# **Planning Sub-Committee A**

Tuesday 11 March 2014 7.00 pm 132 Queens Road, London SE15 2HP

# **Supplemental Agenda No.1**

<b>Item No:</b> 8.	Classification: Open	Date: 11 March 2014	Meeting Name: Planning Sub-Committee A	
Report title:		<b>Addendum</b> Late observations, consultation responses, and further information.		
Ward(s) or groups affected:		College, East W Peckham Rye	alworth, Grange, Peckham,	
From:		Head of Development Management

No.	Title	
Appendix A	Correct map for item 8.4

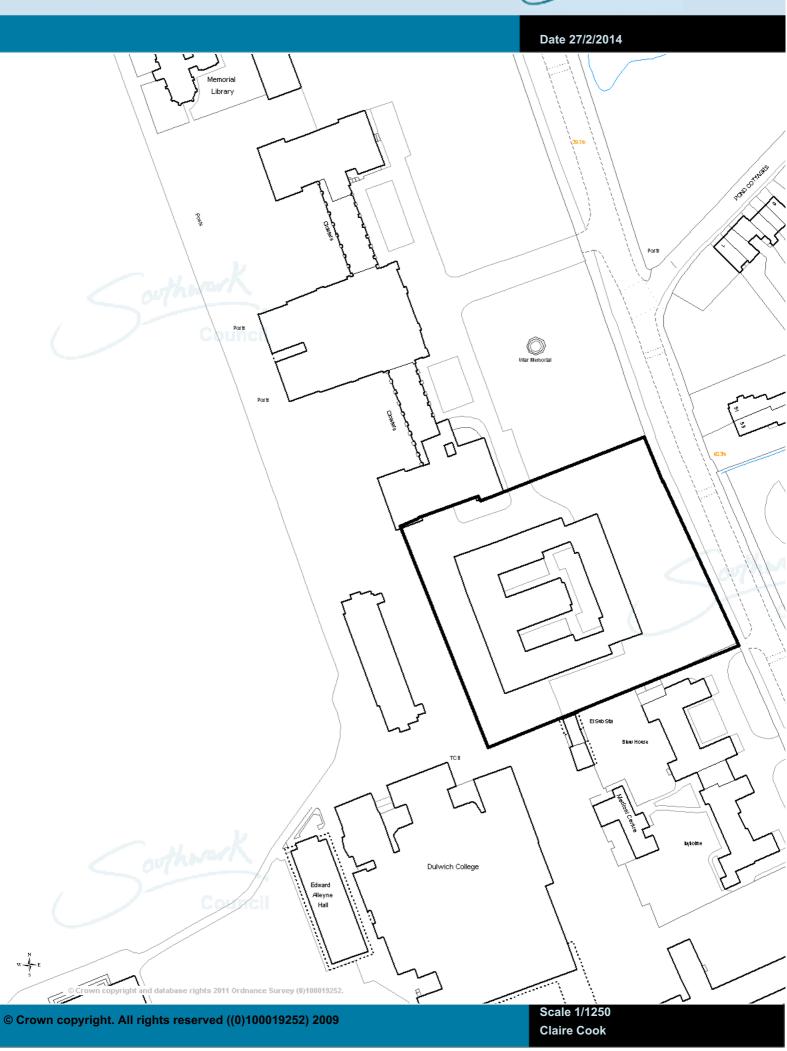
The comments received raises concerns that the main report does not appear to take account of the relevant case law in respect of MOL. The resident claims that it appears that Southwark are relying on the fact that the harm caused to the Metropolitan Open Land (MOL) is slight as the very special circumstances justifying approval.

The courts have emphasised on more than one occasion that the circumstances must indeed be "very special", as opposed to common or garden planning considerations. The resident then provides an example of case law. The objector also highlighted that case law has been established that the "absence of harm" will rarely be sufficient to constitute very special circumstances.

The objector therefore requests an update to indicate what the very special circumstances are to justify what is accepted to be inappropriate development.

As stated in the main report under the Principle of Development section, in respect of MOL the proposed development for the creation of classrooms does not fall within the definition of `appropriate' development, and therefore this proposal has been considered as 'inappropriate' development.

There is a general presumption against inappropriate development in Metropolitan Open Land (MOL). When considering any planning application, substantial weight should be given to any harm to any MOL. Para 87 of the National Planning Policy Framework (NPPF) confirms that inappropriate development should not be approved except in very special circumstances. Very special circumstances to justify appropriate development will not exist unless the harm by reason of the inappropriateness, and any other harm, are clearly outweighed by other considerations.

In this case there are considered to be very special circumstances as the proposal is situated within an established group of school buildings and there would be educational benefits from the development. The new science block would provide for much improved facilities. Strategic Objective 1B of the Core Strategy advises that Southwark will be a place that creates positive futures by building, redeveloping and improving educational facilities with good access for everyone. Furthermore, Strategic Policy 4 'Places for Learning, Enjoyment and Healthy Lifestyles' of the Core Strategy also encourages the building of new schools and improving existing schools to provide improved education opportunities. It is considered very important that the Council continue to increase the quality of our existing schools.

The proposal would replace an existing building in a broadly similar position, application is a section 73 application (material minor amendment) to approved scheme 12-AP-3691 and the principle of development has already been established. The openness of the surrounding MOL is not considered to be impacted upon given the circumstances.

In light of the above comments, there are very special circumstances to justify the development.

Whilst Officers have indicated above that this proposal has been considered as 'inappropriate' development in MOL, but there are very special circumstances to justify this, Members should also be made aware that the NPPF highlights the exceptions to construction of new buildings in Green Belt (in this instance the MOL as it is within London). Para 89 of the NPPF lists those exceptions where they may be appropriate development and in particular highlights that limited infilling or the partial or complete redevelopment of previously developed sites (brownfield land), which would not have a greater impact on the openness of the Green Belt (MOL) may be possible. The site already comprises an existing building and is considered brownfield land in this instance and the development would not impact on the openness of the surrounding MOL.

Overall, officers maintain the view that the proposal is justified in MOL given the particular circumstances that pertain here.
